Sundry Print Report

Well Name: HUERFANITO UNIT

Type of Action: Plug and Abandonment

HILCORP ENERGY COMPANY
HUERFANITO UNIT 21
P&A NOI

P&A Proposed WBD

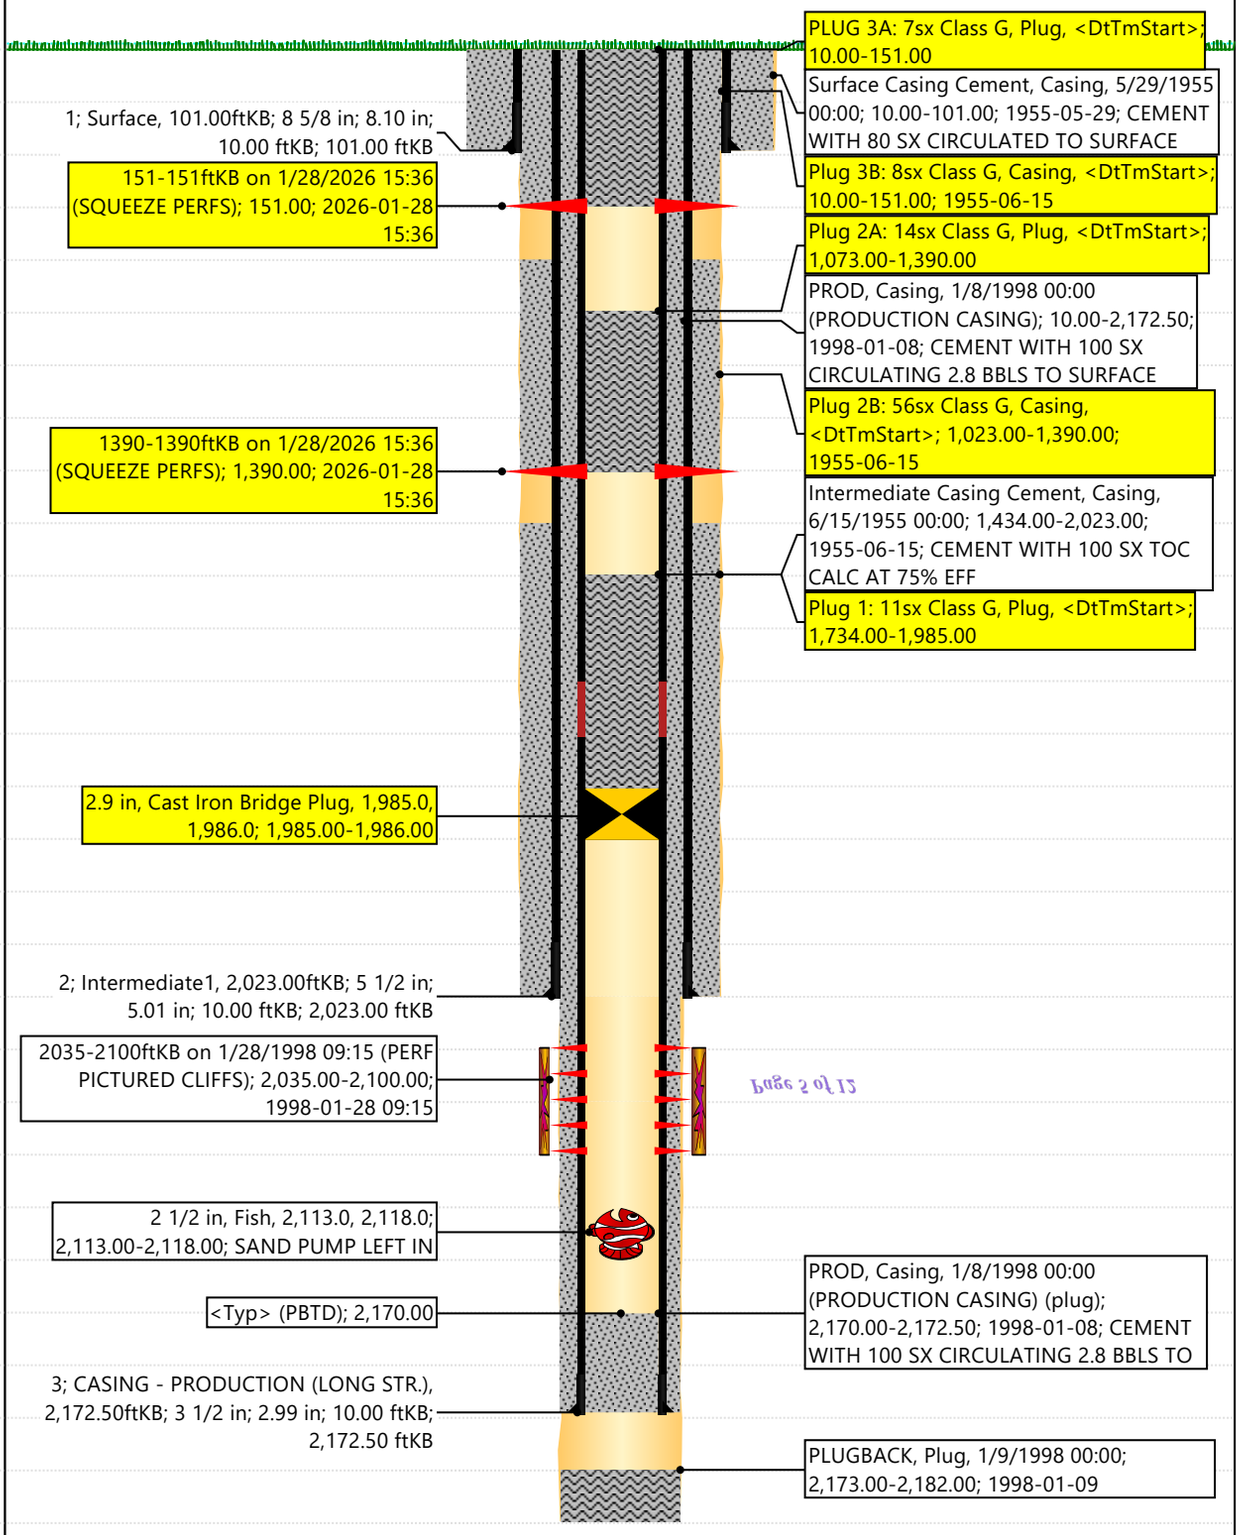
Operator selected formation tops are appropriate. No changes to the procedure.

2. The following modifications to your plugging program are to be made:
   a. No changes to the procedure.

You are also required to place cement excesses per 4.2 and 4.4 of the attached General Requirements.
